REGIONAL REVIEW NOTICE

ARC REVIEW CODE: R1410211

Name of Proposal: 3354 and 3356 Peachtree Road Development

GRTA DRI SITE PLAN

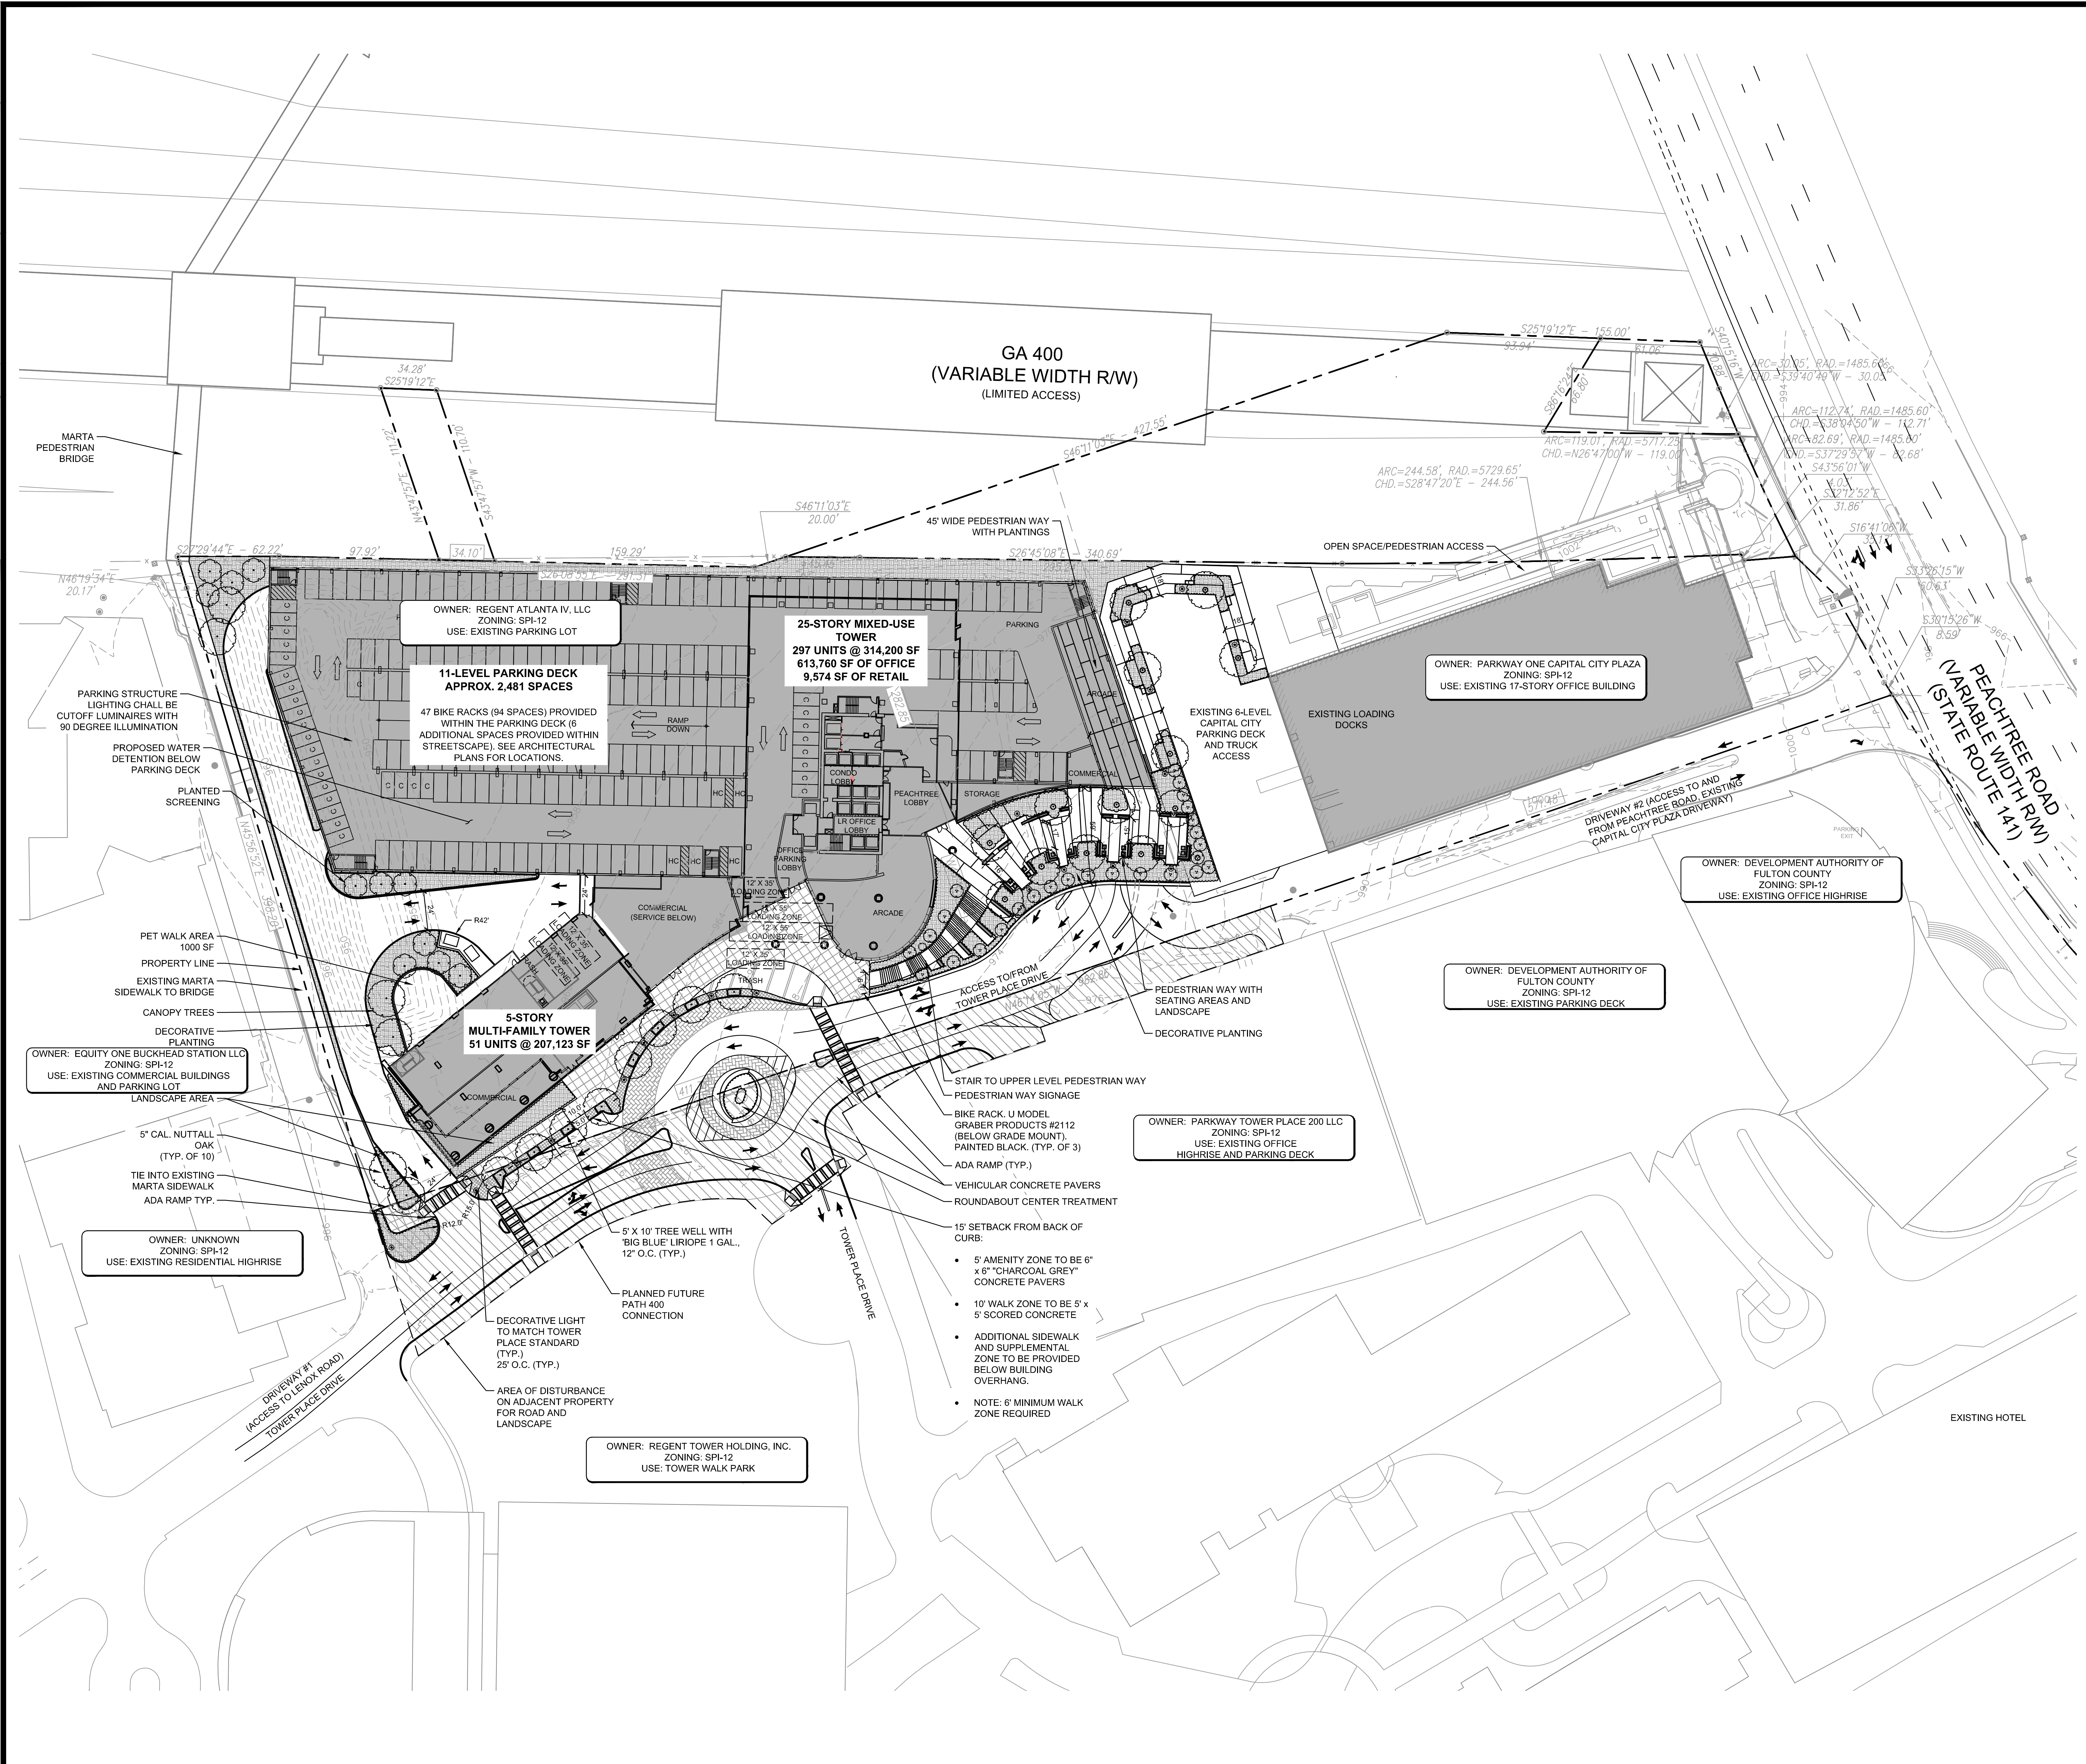
The site plan shows a new pedestrian connection along Tower Place Drive, and continuing up along the Capital City Plaza Building parking deck and then finally connecting to Peachtree Street by running between the Capital City Plaza Building and GA 400. There are some significant questions surrounding the design of this pedestrian connection, and its incorporation into the public space. The pedestrian connection is advertised as a public pedestrian connection in the DRI pre-review information, but it appears that the connection utilizes the top of a private parking facility. It is encouraged that any pedestrian connection that is advertised as a public connection be fully open and accessible to the public.

The newly planned roundabout at the Tower Place Drive intersection in front of the project site is a great addition to help promote pedestrian safety. It is highly encouraged that the dimensions of the roundabout be reviewed to verify whether or not the BUC Shuttle (up to 29 foot vehicle) will have the appropriate turn radius at the intersection, as well as appropriate access for fire and emergency vehicles.

Recommendation: The committee did not note the inclusion of bicycle parking on the plans and recommends the applicant meet or exceed these requirements given the proximity to PATH400. Furthermore, the committee recommends the applicant work with the City of Atlanta to become a host site for a “Bikeshare” installation as part of the citywide program.

The committee has concerns about the operation of the “intersection” where the service drive and parking deck access for the proposed development, the service Drive for the shopping center, the MARTA pedestrian walkway and the access to Tower Place 100 intersect with Tower Place Drive. The committee recommends this intersection be studied in detail by traffic engineers to determine a safer, more efficient configuration.

The committee has concerns about the configuration of the proposed traffic circle, specifically the merge of two northbound lanes of traffic into one lane immediately upon exiting the circle. The committee recommends traffic engineers study this configuration in greater detail to modify or eliminate this condition.

The committee notes the encroachment of the roadway facilities into Tower Place Park and recommends the applicant ensure the conservation easement over Tower Place Park is not compromised.
